**SPG9000**

**Timing and Reference System**

**Release Notes**

This document supports firmware version 3.1.1

▼ System Information

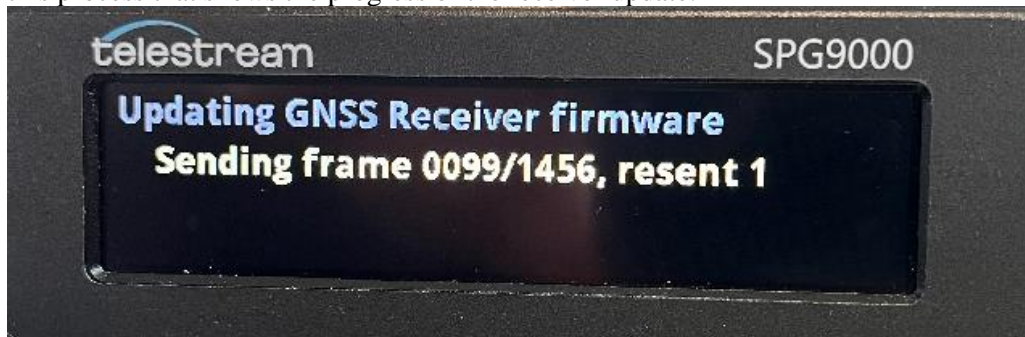
- From the front panel **SYSTEM : INFO** menu, additional submenus have been added for **HOST ID** and for **SERIAL NUMBER**. These values can be useful when identifying the SPG9000 unit when working with Telestream Technical Support.
- The System Information section of the System menu now includes a summary of the network settings for the management interface. These are read-only values on the web interface.

To change the settings for the management interface, you can use the **SYSTEM : NETWORK : MGMT** submenus from the front panel. The hostname, domain name, and DNS server address can also be changed using the HTTP API, by sending a PUT message to the /system/network endpoint. API requests can be sent from the web interface by clicking on the “API Documentation” in the top banner.
